FINAL DRAFT MINUTES

January 18, 2024, Standards Committee Meeting

RE: Minutes from the January 18, 2024, Standards Committee Meeting

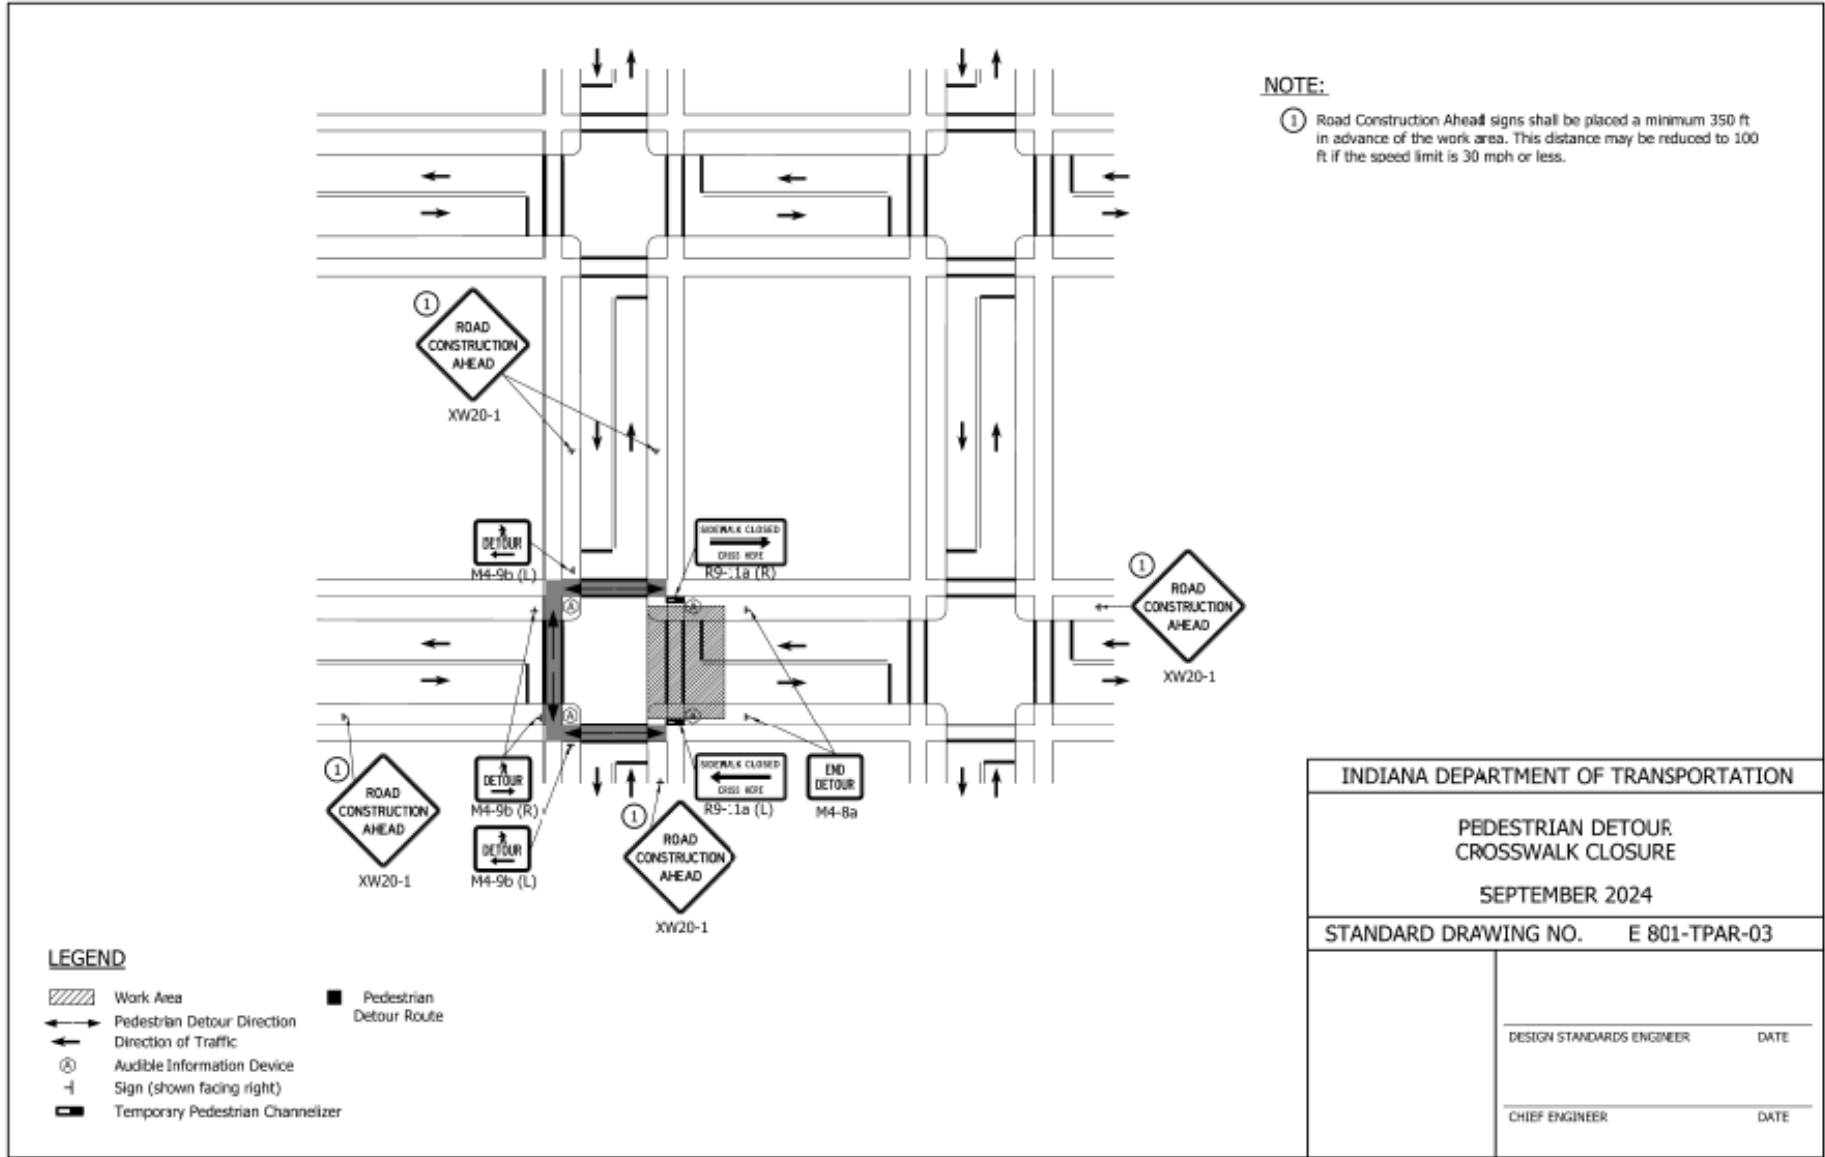
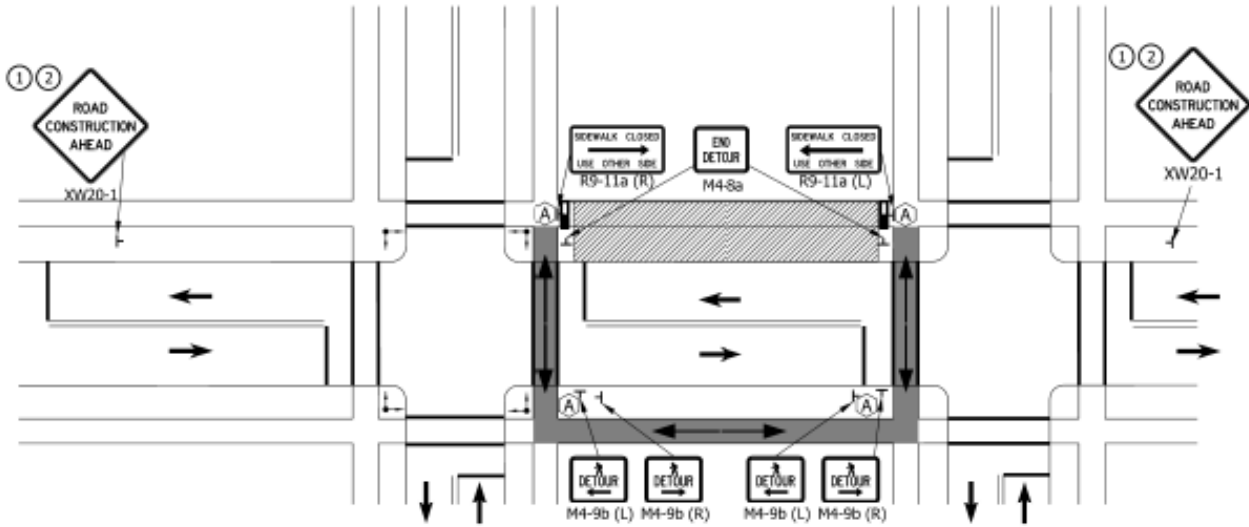
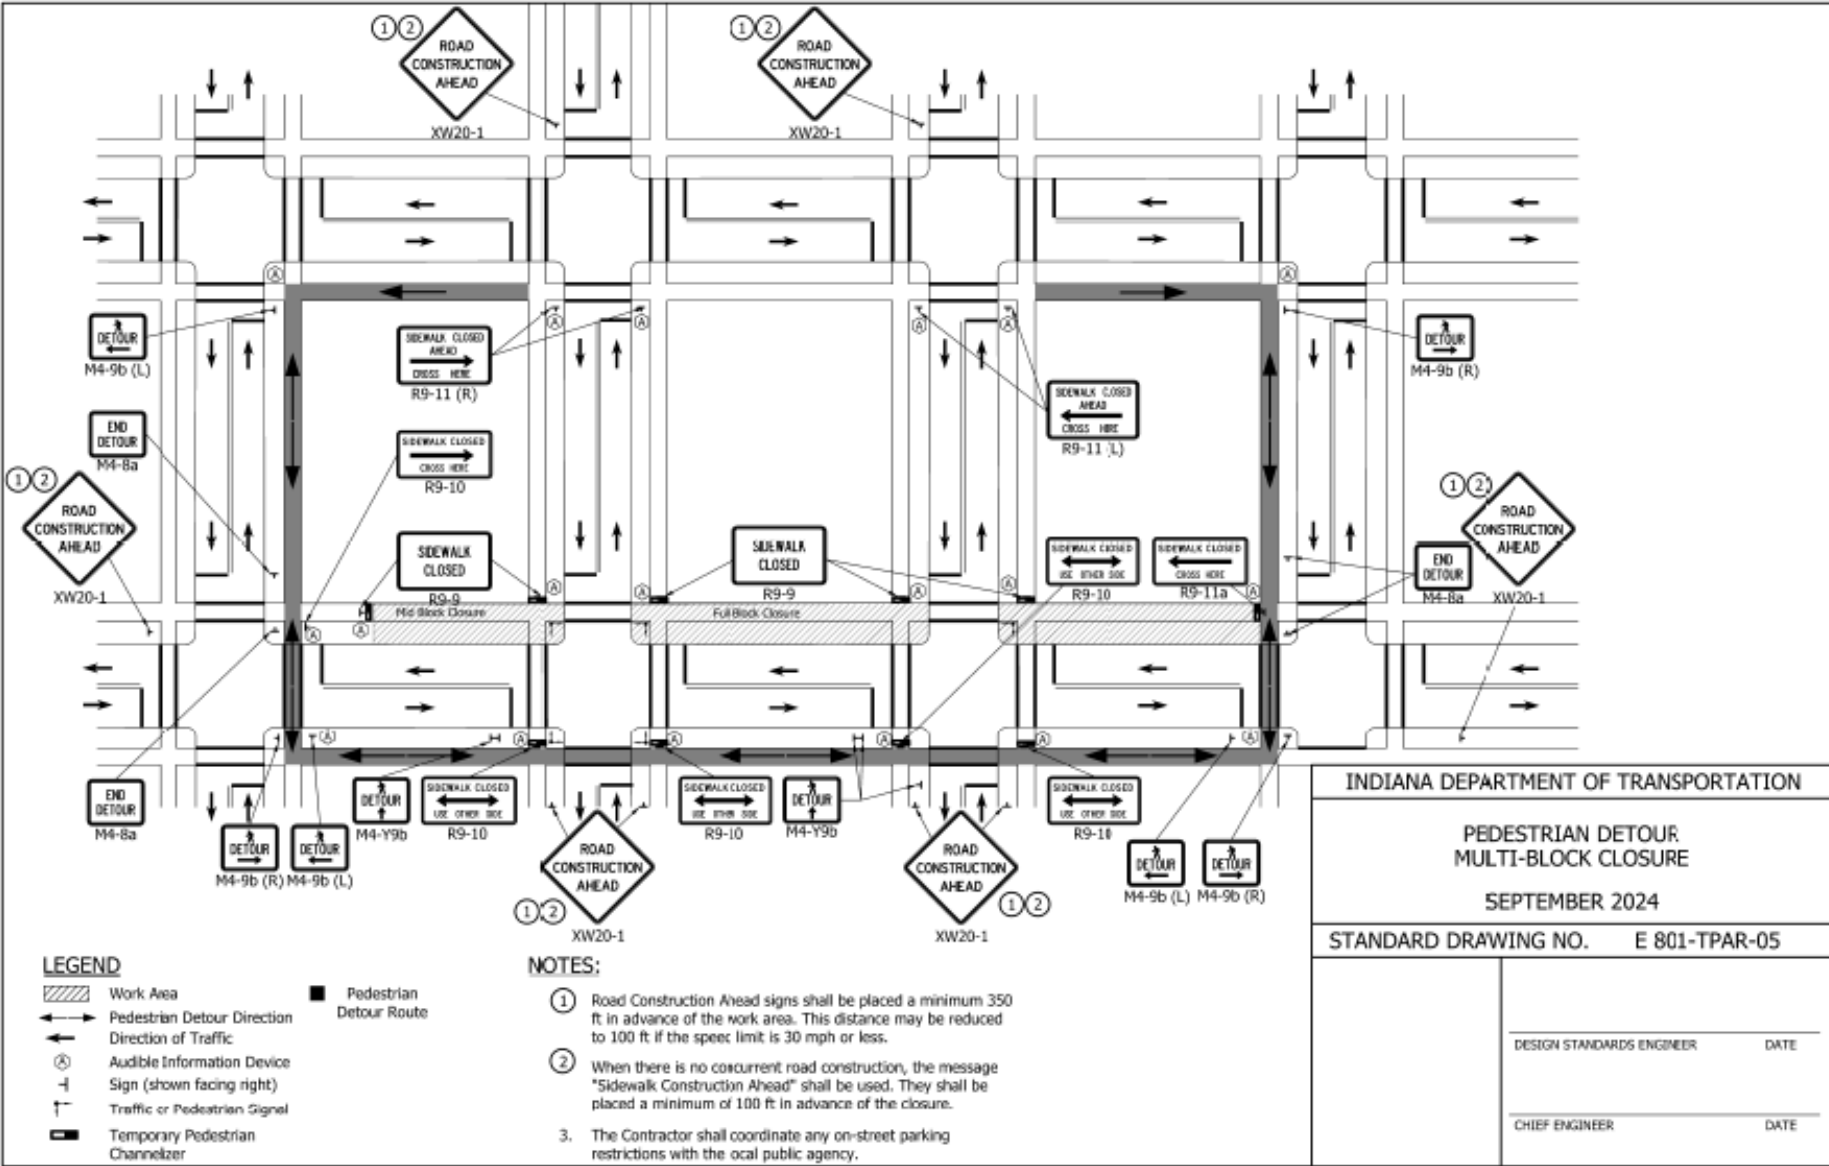
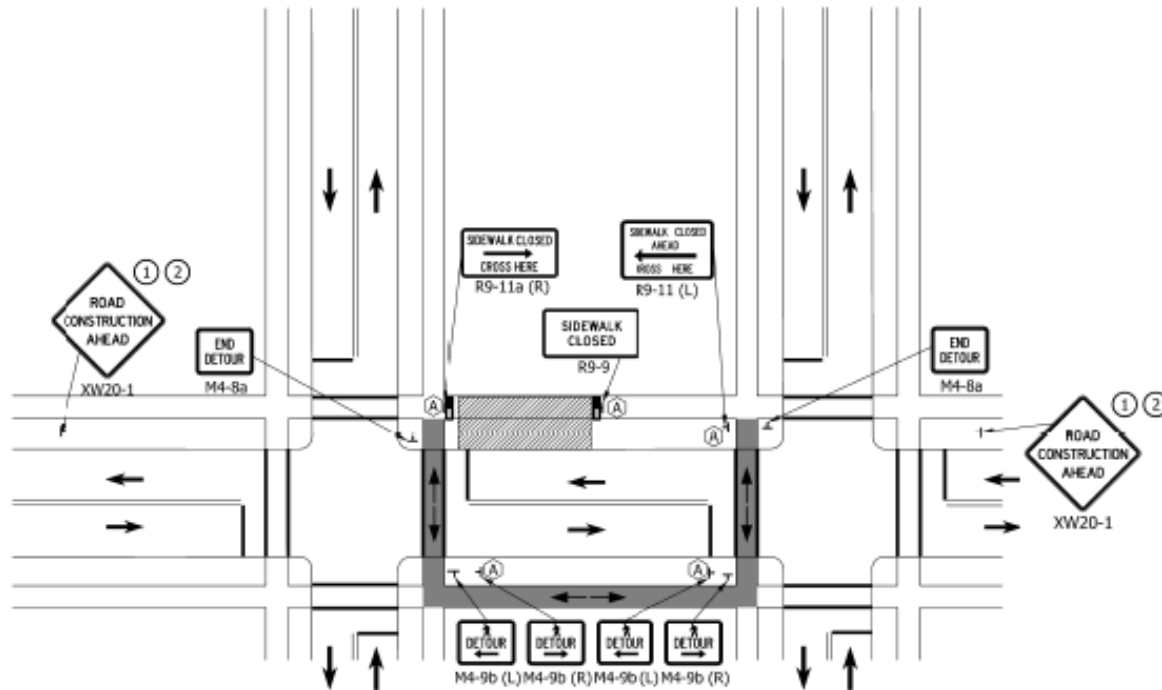
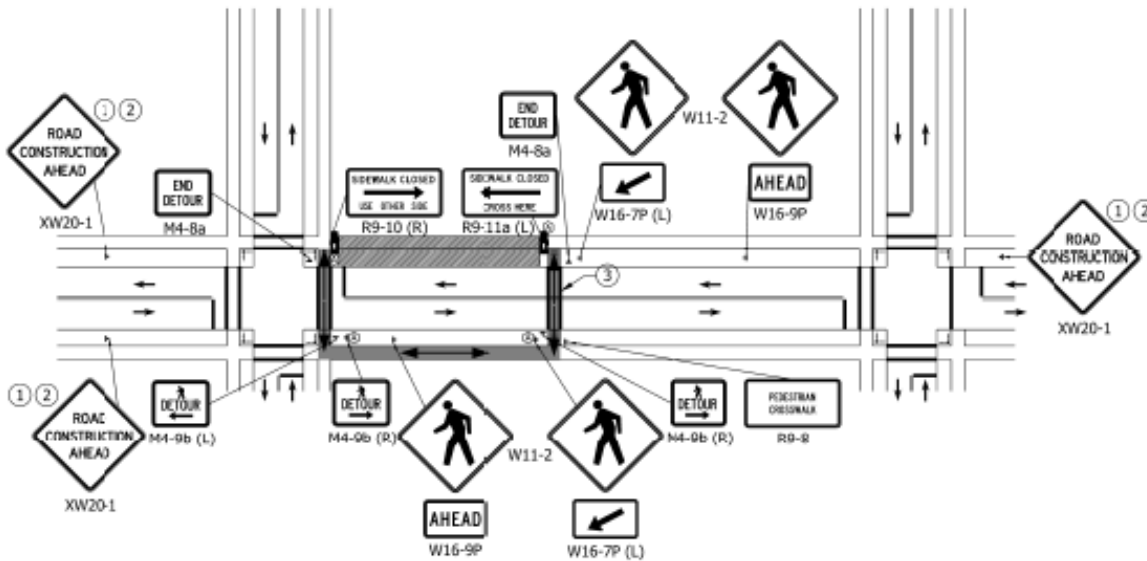
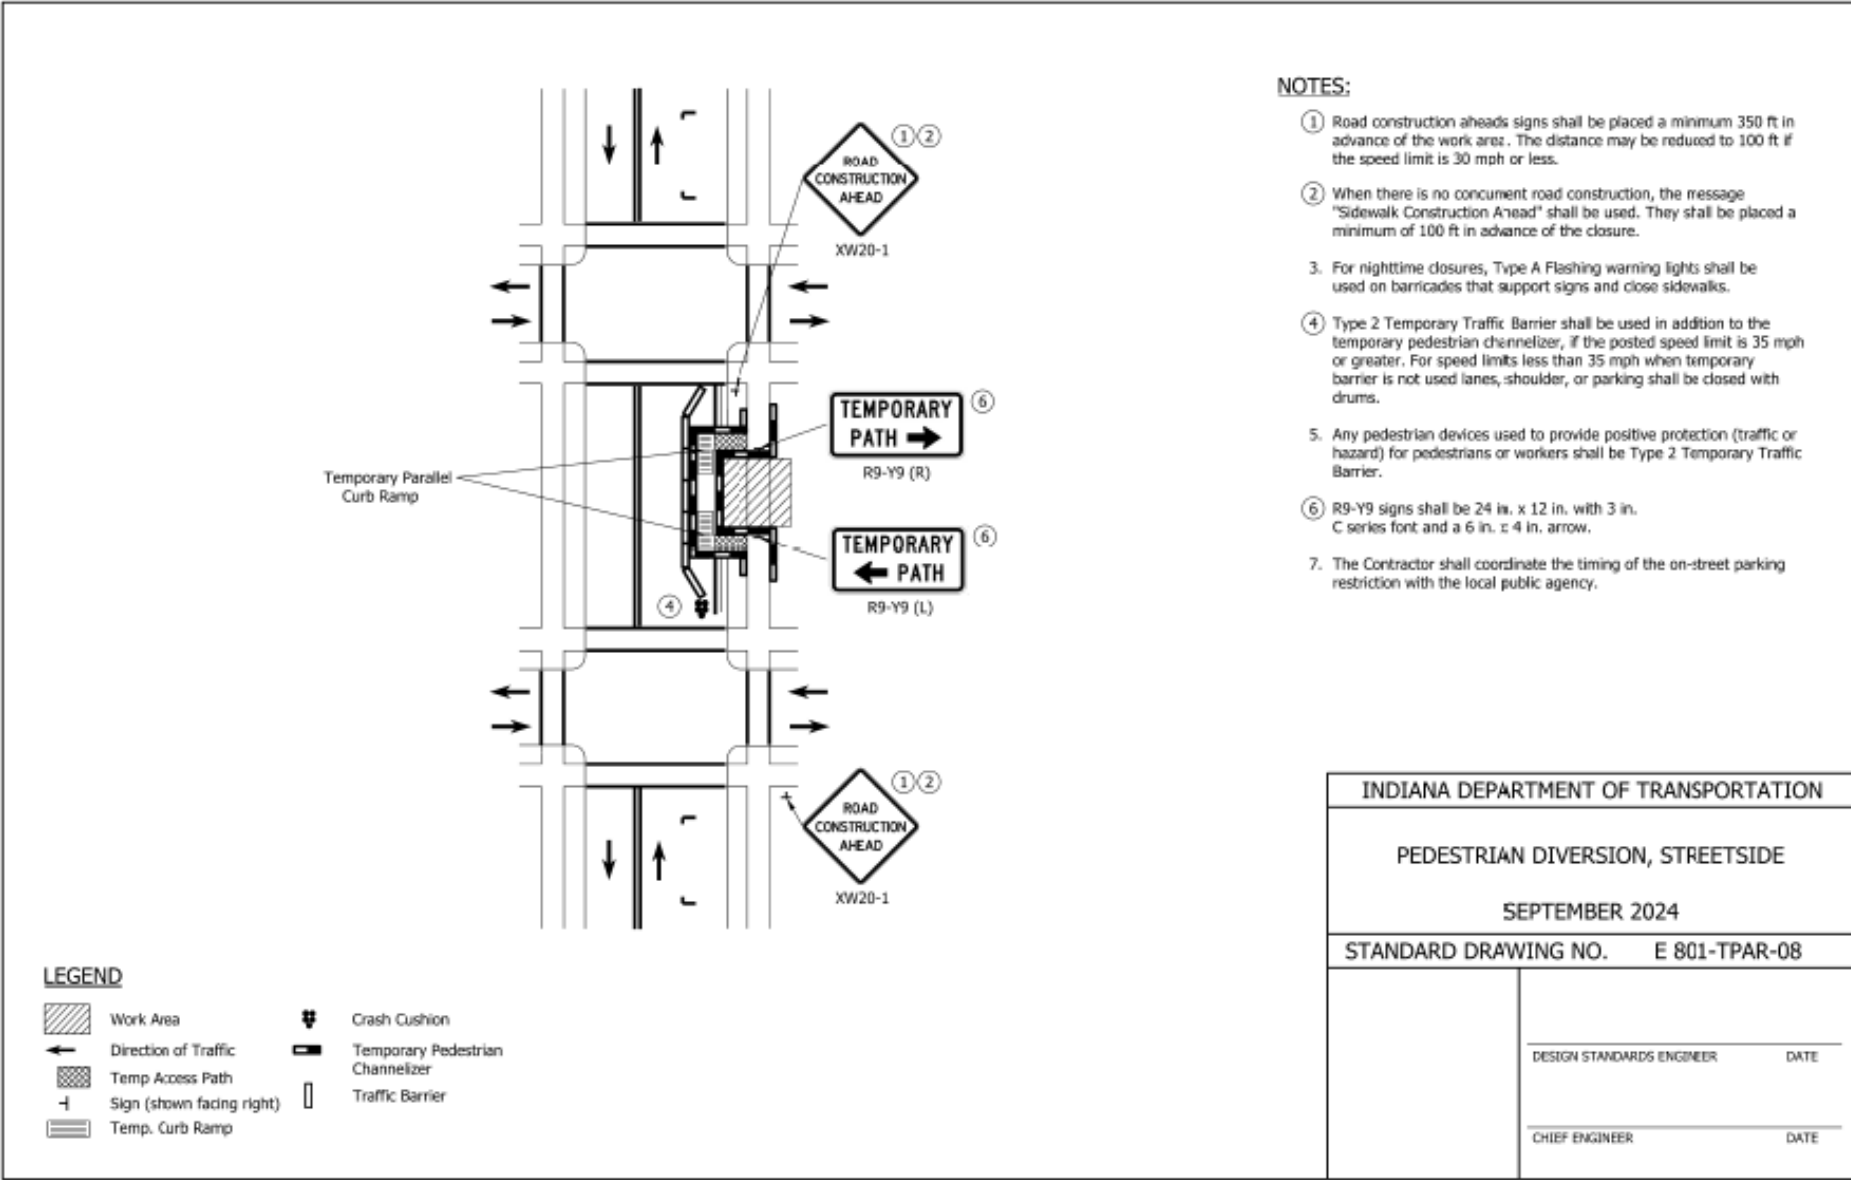
Mr. Koch stated, concerning the 801-TPAR drawings-02, -04, -05, -06, -07, -08, -10: everyone has RCA's. In order to minimize costs, burdens, and liability if the note is overlooked, and the associated costs to change out signage as the work progresses and to maintain a stock of the signs; please consider striking note #2. Also, for drawings 801-TPAR-03, -05, -07, understand we are attempting to capture both approaching sidewalks yet we are adding a considerable amount of sign clutter. Are two RCA's needed as a single is utilized elsewhere? And for 801-TPAR-10, the corner diversion requires 'sidewalk construction ahead' yet includes note #2. Similar to elsewhere, should RCA's be required 1st, ideally only RCA's for simplification. Mr. Boruff responded that we could make it an option, which would eliminate the liability and added costs concerns. The Contractor can use RCA's if they have them in stock or would otherwise prefer the alternate, more precise message. Mr. Koch said that sounds reasonable. The drawings have been revised as shown, following discussions by Mr. Duncan from FHWA, Mr. Koch, Ms. Smutzer, Mr. Davis, and Mr. Boruff.
